USB Power Delivery ENGINEERING CHANGE NOTICE

Title: Deprecate the GotoMin/GiveBack Features and Update Power Reserve

**Applied to: USB Power Delivery Specification Revision 3.2
Version 1.0**

Figure 7-43 “Transition Diagram for a GotoMin Current Decrease”

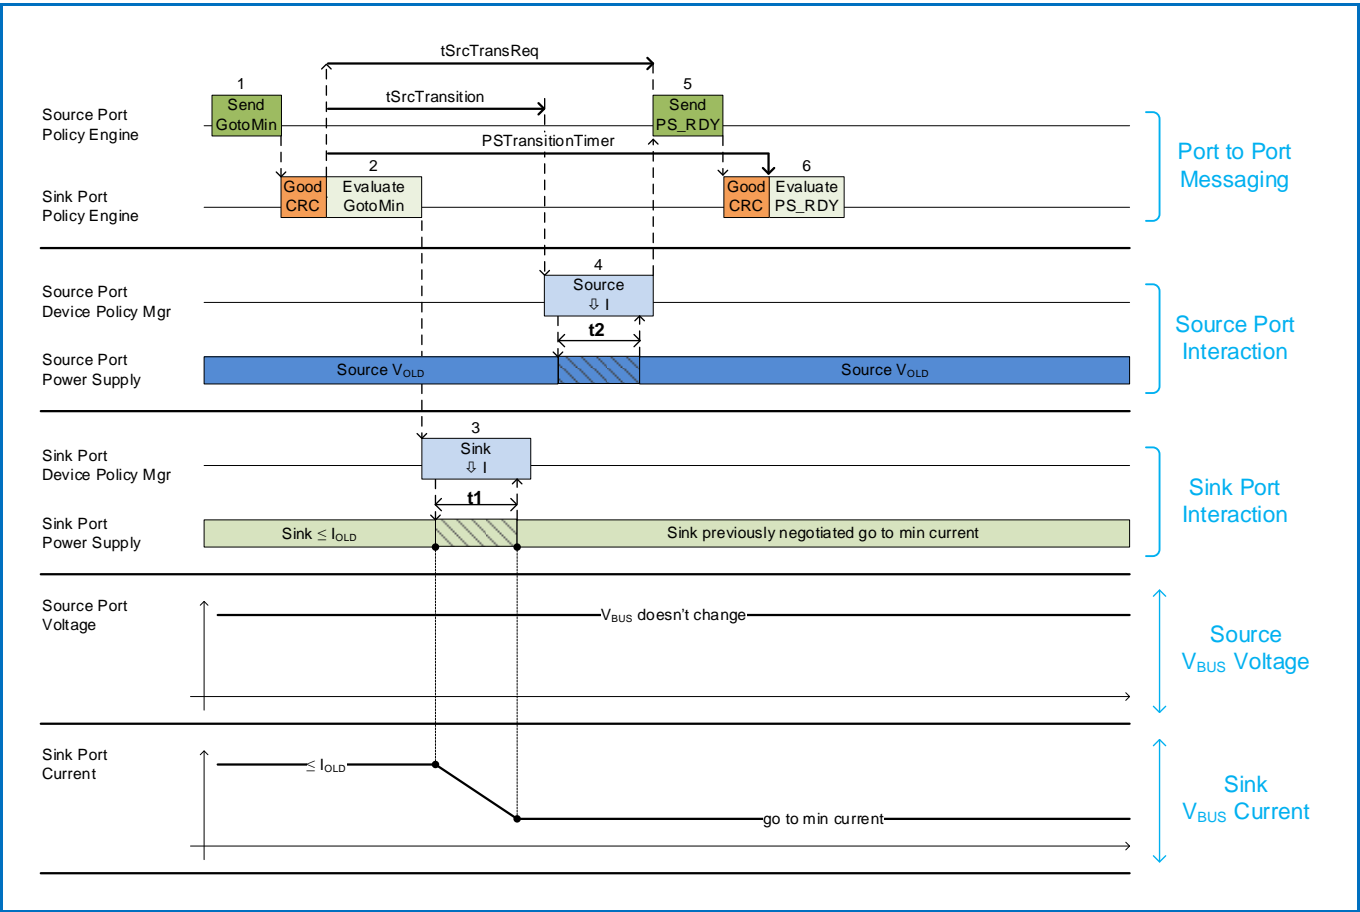
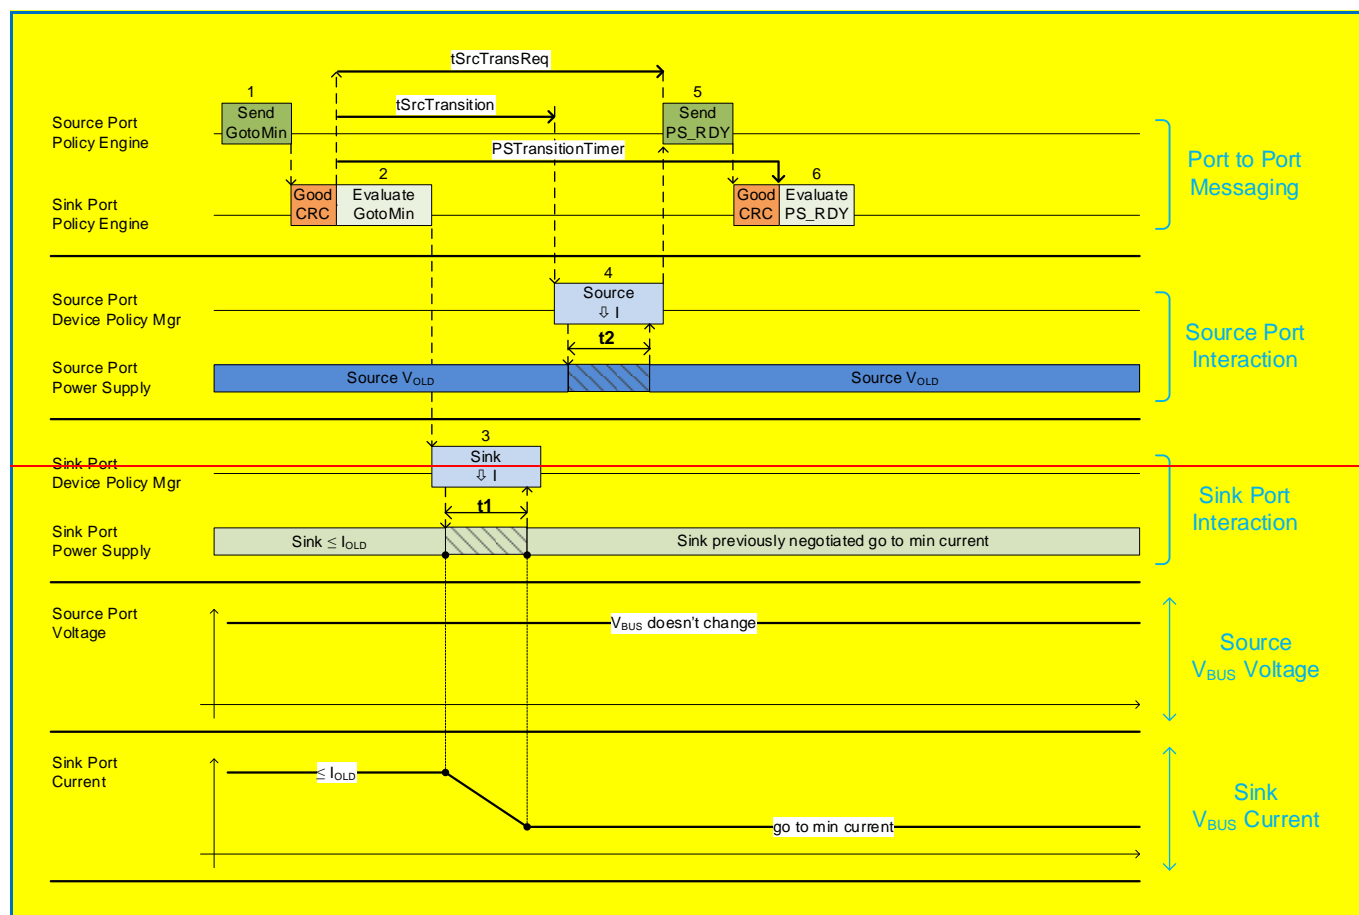
The interaction of the System Policy, Device Policy, and power supply that **Shall** be followed during a GotoMin current decrease is shown in **Figure 7-43 “Transition Diagram for a GotoMin Current Decrease”**. The sequence that **Shall** be followed is described in **Table 7.21 “Sequence Description for a GotoMin Current Decrease”**. The timing parameters that **Shall** be followed are listed in **Table 7.25 “Source Electrical Parameters”**, **Table 7.26 “Sink Electrical Parameters”**, and **Table 7.27 “Common Source/Sink Electrical Parameters”**.

Figure 8-8 “Successful GotoMin operation”

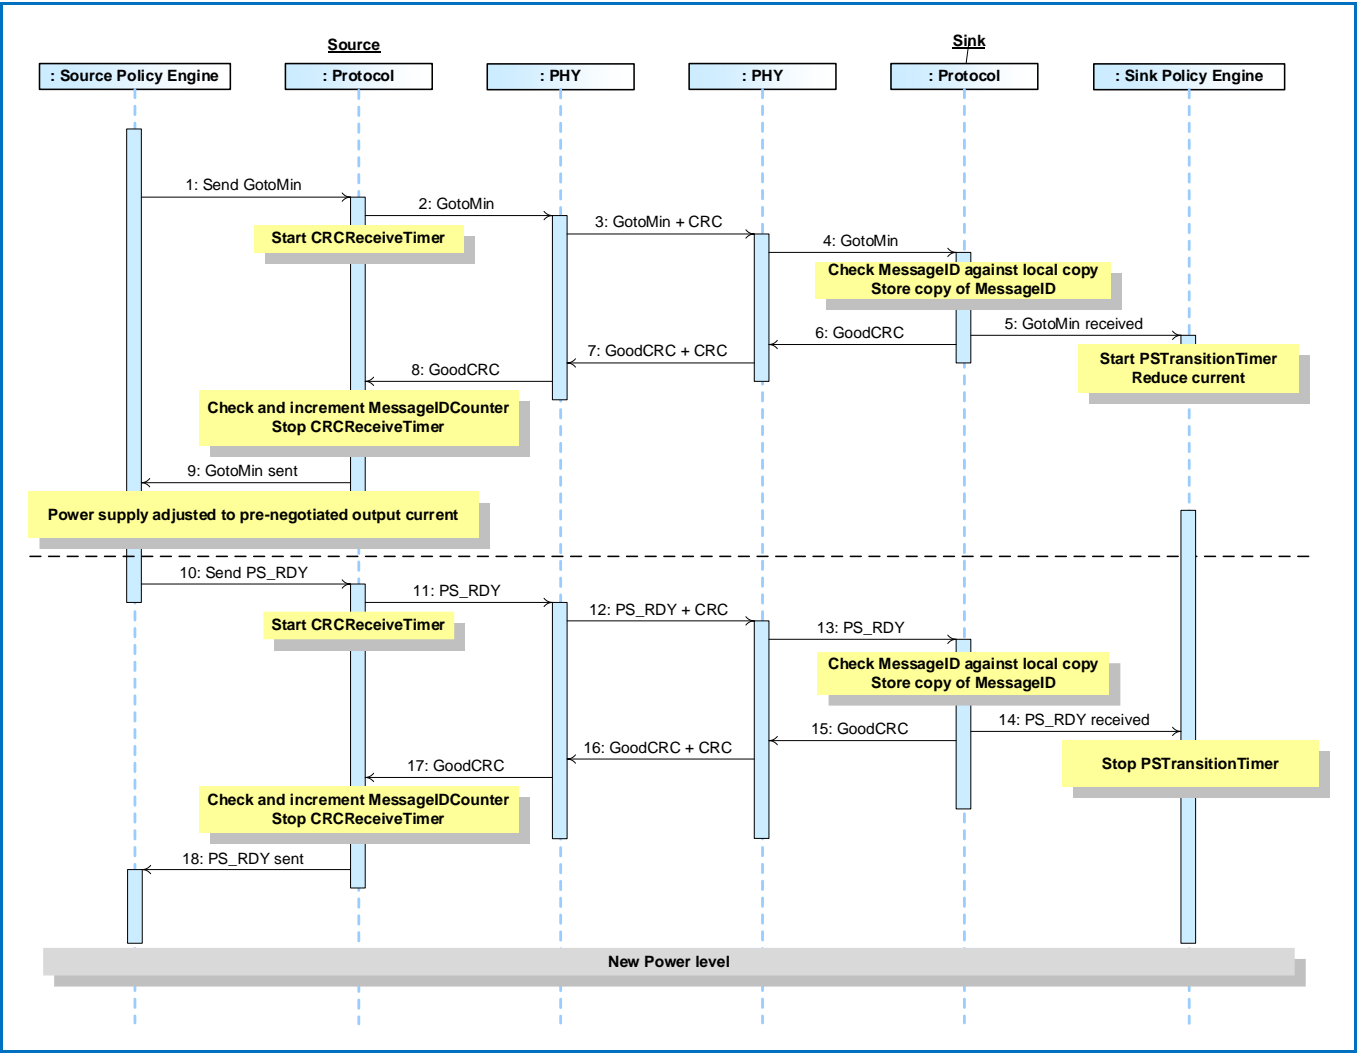
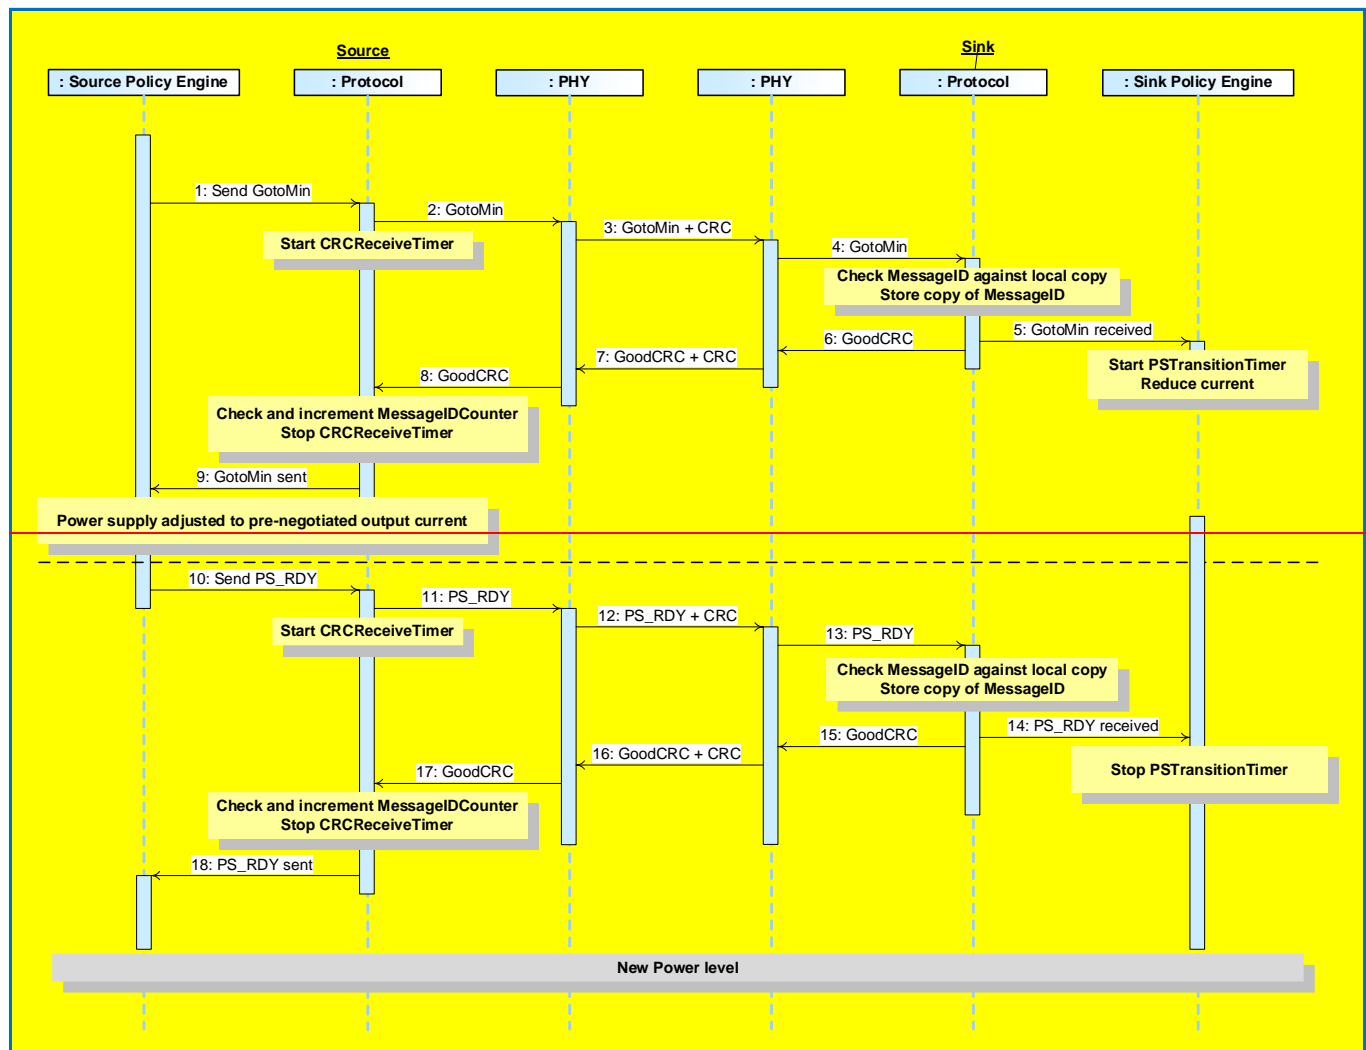
This is an example of a GotoMin operation. **Figure 8-8 “Successful GotoMin operation”** shows the Messages as they flow across the bus and within the devices to accomplish the GotoMin.

Figure 8-134 "Source Port State Diagram"

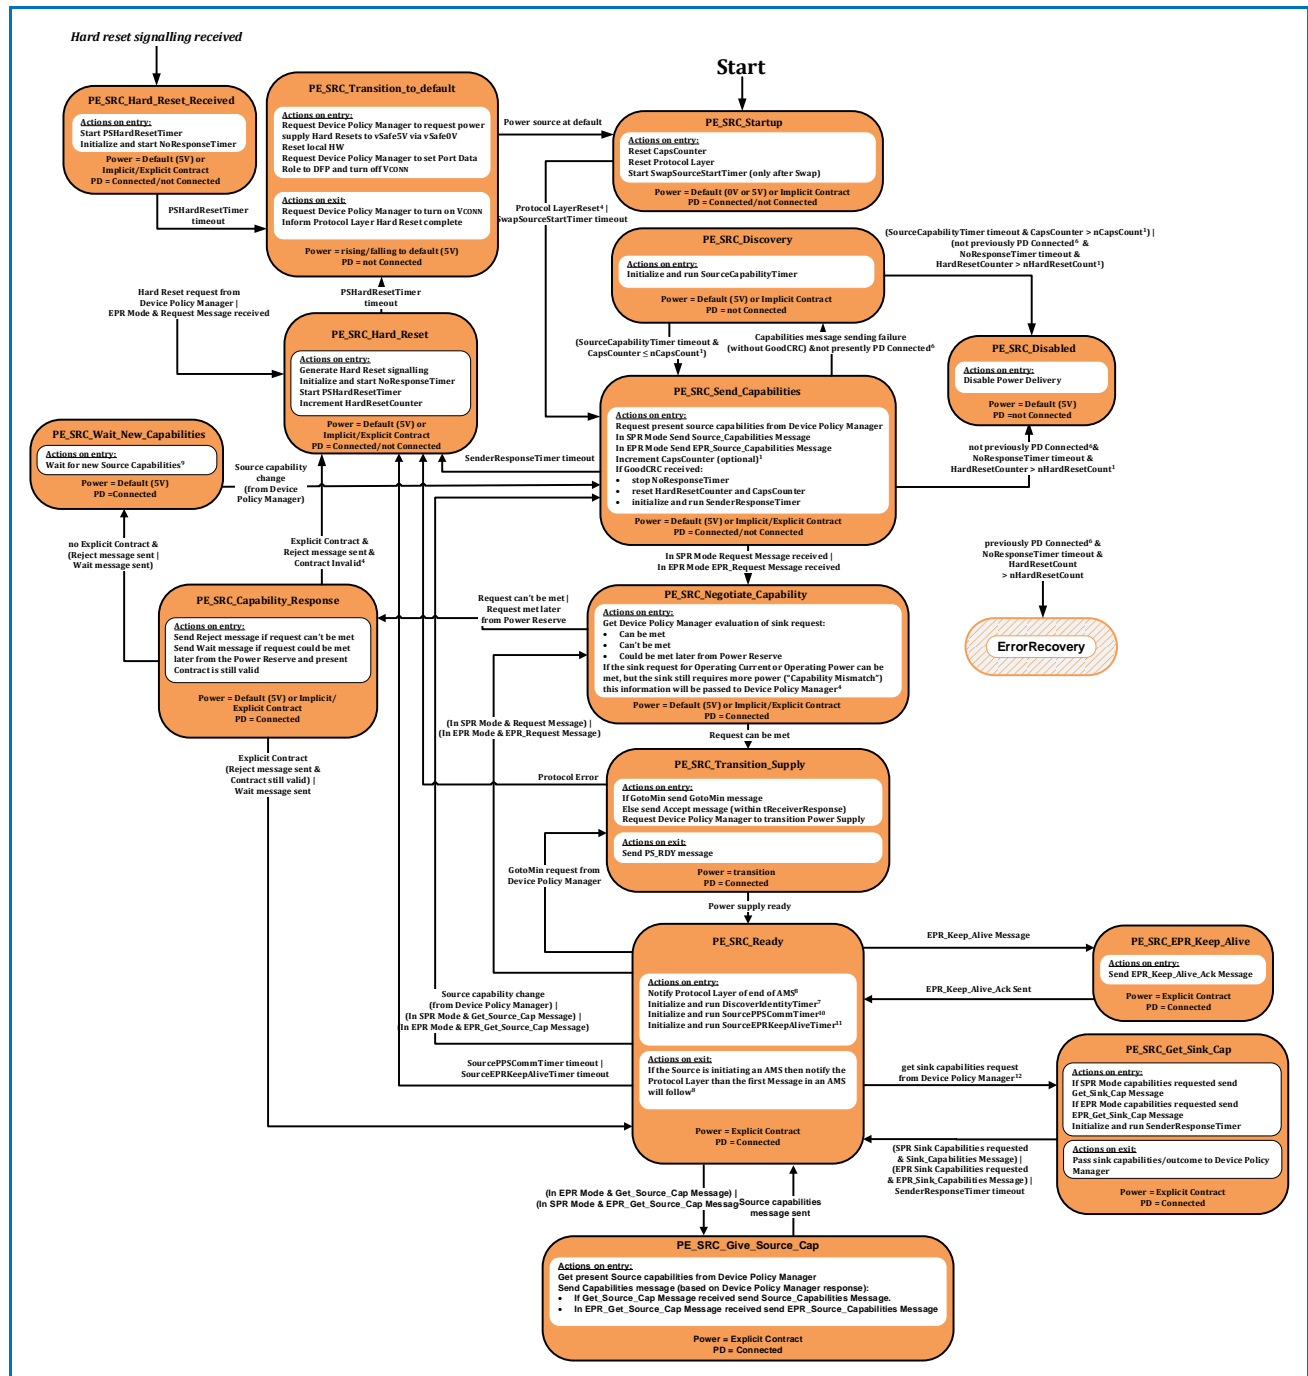
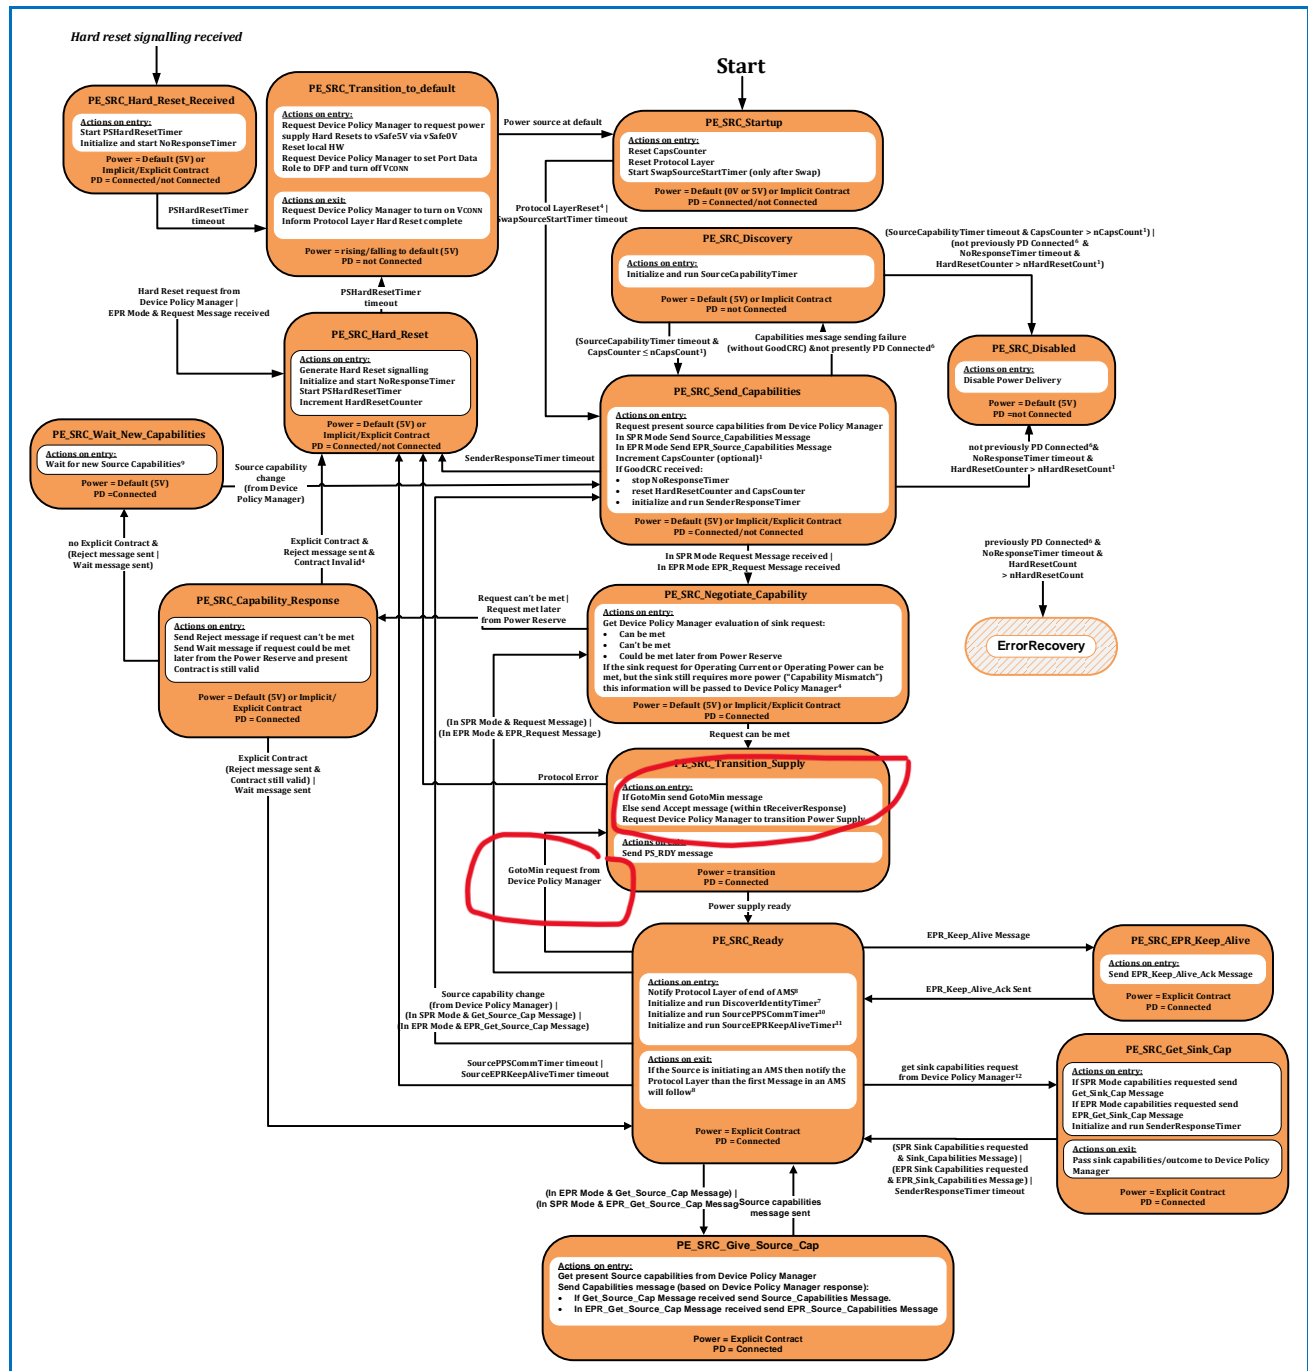
To: need to remove GotoMin from figure

Figure 8-135 "Sink Port State Diagram"

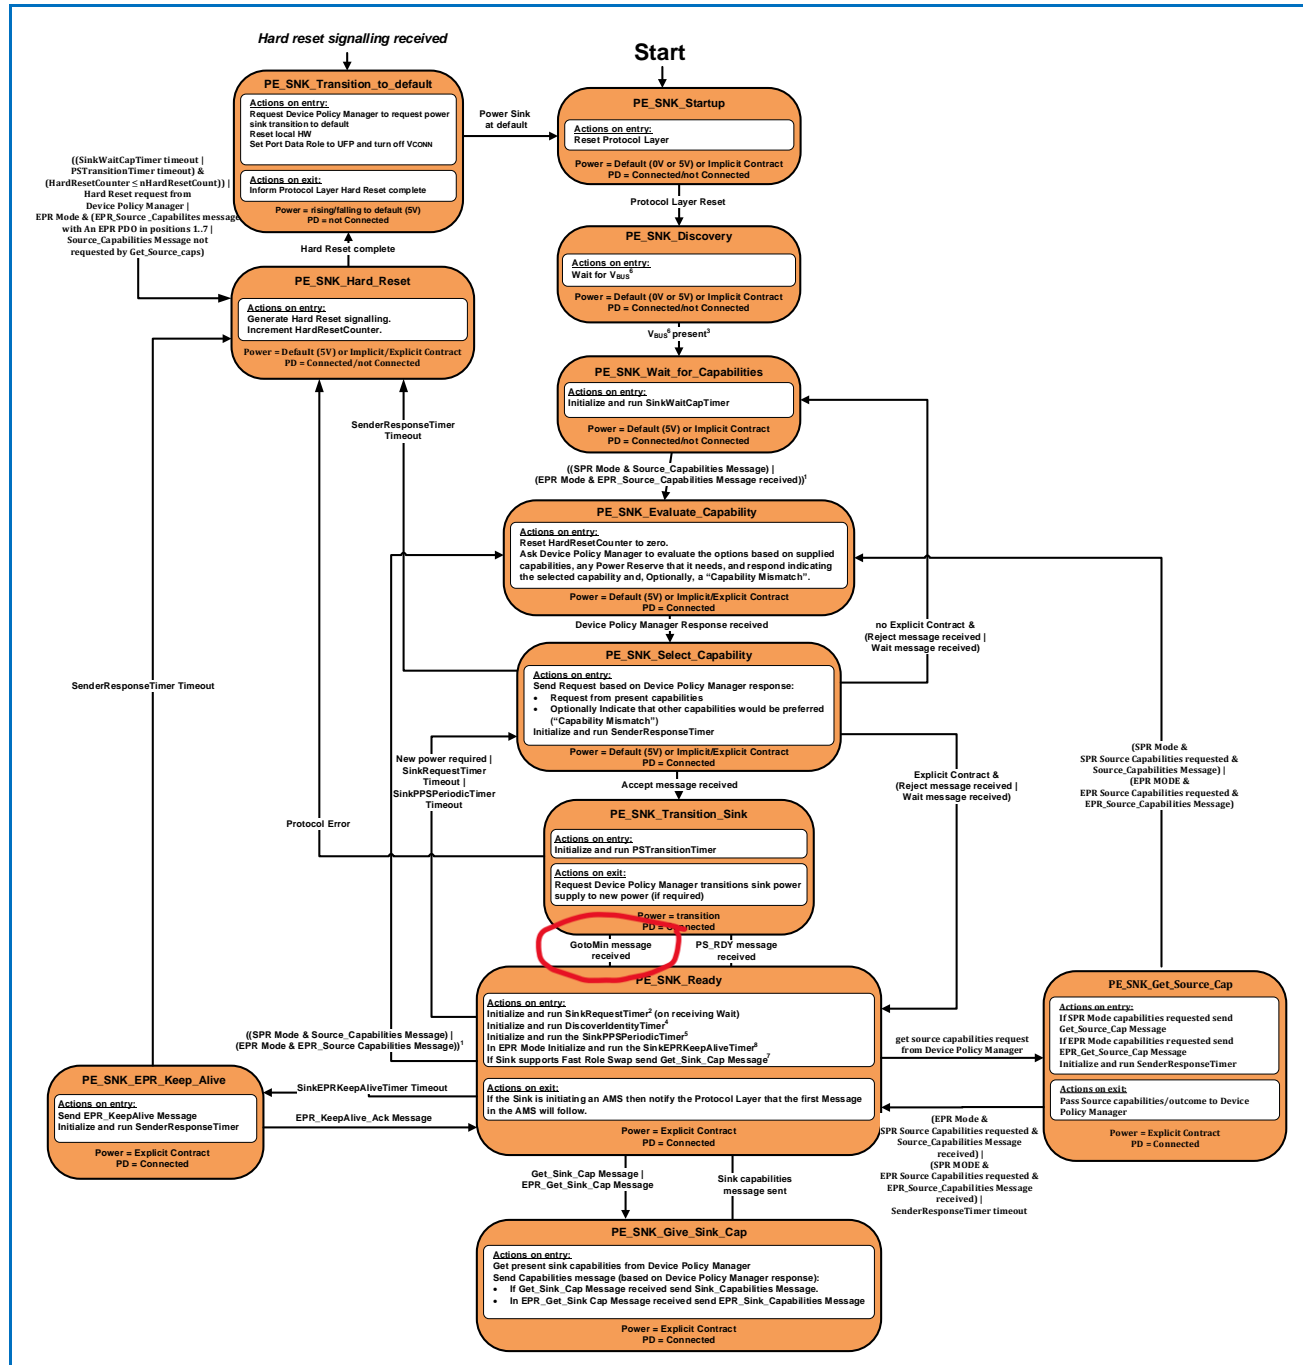
To: **need to remove GotoMin from figure**
